Access Compliance Report

(Curb Ramps)

Intersection ID: 14620	Main Street: EUCLID_AV	Cross Street: MCDONALD_AV	Location: W
ADA ID: 8675074F3E34	Ramp Type: PerpDiag	Initial Pass/Fail: Fail	Overall Compliance: No
Severity Score: 22.5			
Codes/Mitigation Info/Possible Solution		Field Measurements/Component Compliance

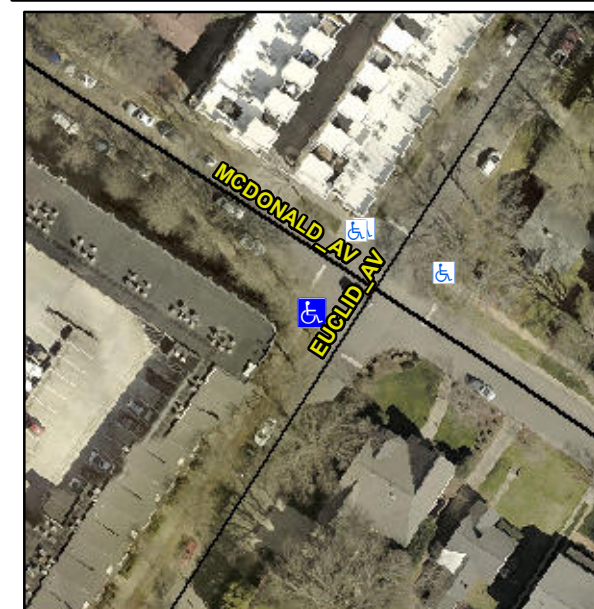
R304.5.1, R304.2.2, R304.5.3

Compliance	Description	Data	Compliance	Description	Data
N/A	Ramp Length (in)	96.0	No	Ramp Slope (%)	9.1
No	Ramp Width (in)	47.0	No	Ramp XSlope (%)	2.1
N/A	Flare Type LT	N/A	N/A	Flare Type RT	N/A
N/A	Flare Slope LT (%)	N/A	N/A	Flare Slope RT (%)	N/A
N/A	Flare Traversable LT?	N/A	N/A	Flare Traversable RT?	N/A
N/A	Landing Length (in)	N/A	N/A	DWS Provided?	N/A
N/A	Landing Width (in)	N/A	N/A	DWS Contrast?	N/A
N/A	Landing Slope (%)	N/A	N/A	DWS Length (in)	N/A
N/A	Landing X Slope (%)	N/A	N/A	DWS Full Width?	N/A
N/A	Landing Curb? (Y/N)	N/A	N/A	DWS Offset (in)	N/A
N/A	Shared Landing?	N/A			
N/A	Gutter Ponding?	N/A	N/A	Gutter Slope (%)	N/A
N/A	Gutter Lip Ht (in)	N/A	N/A	Gutter X Slope (%)	N/A
N/A	Painted X Walk1?	No	N/A	Painted X Walk2?	No
	X Walk 1 Direction	To SE		X Walk 2 Direction	To NE
N/A	X Walk 1 Width (in)	N/A	N/A	X Walk 2 Width (in)	N/A
	X Walk 1 Slope (%)	2.5		X Walk 2 Slope (%)	0.8
	X Walk 1 X Slope (%)	0.3		X Walk 2 X Slope (%)	2.3

Remove & Replace Curb Ramp With Two New Directional Ramps or Equivalent.
